Our Ref: PL/25/0229
Your Ref:

30th April 2025

RE: PROPOSED WORKS TO 2 NO. PLANE TREES, 3 NO. ORNAMENTAL PEAR TREES AND 11 NO. ACER TREES AT CAVERSHAM PLACE, RICHFIELD AVENUE, READING, RG1 8BY - SUBJECT TO TREE PRESERVATION ORDER NUMBER 19/10

Figure 4 (T5 Acer) - Indicative Radial Crown Reduction

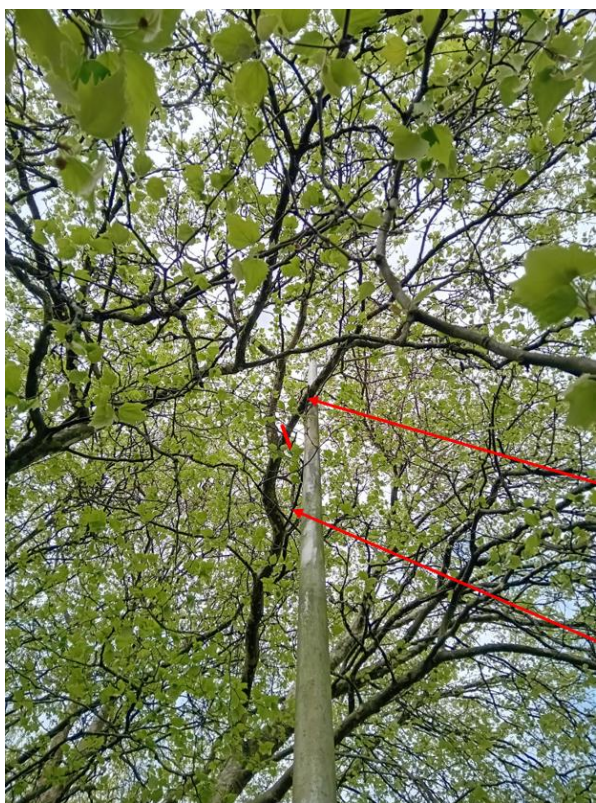
- T4 Acer - Prune to provide clearance from the lamppost, back to indicative previous reduction points (See Figure 2), leaving suitable growth points.
- T5 Acer - Reduce the radial crown spread and height by approx. 4-5m, as indicatively shown (see Figure 3 and Figure 4), leaving suitable growth points.

Figure 5 (T7 Plane) - Branch Removal for Lamppost Clearance

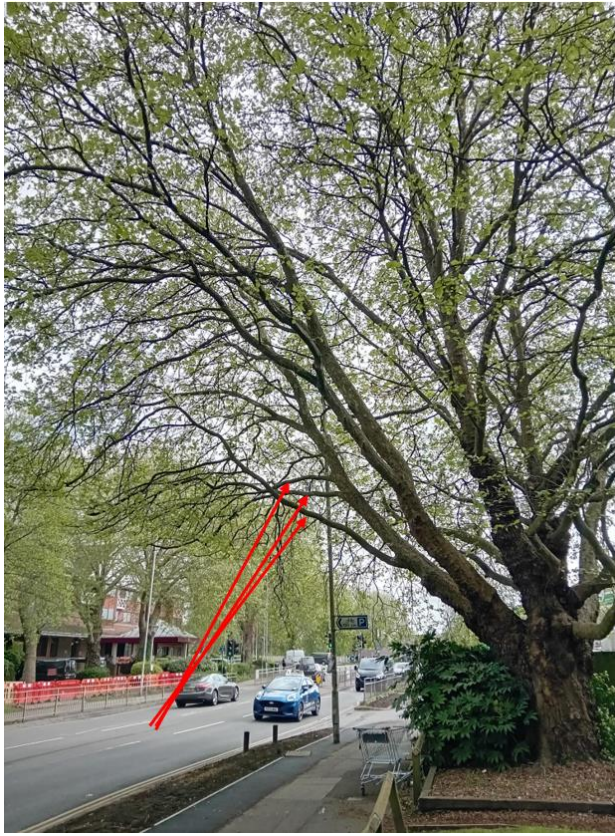
- T7 Plane - Prune to clear lamppost by 0.5m by removing/reducing minor growth only, including removal of 1no. secondary branch to source and 1no. minor branch below, to the source, which is in contact with the lighting column (See Figure 5). Crown lift over the road, by removing 3no. secondary branches to the source (See Figure 6 and Figure 7).
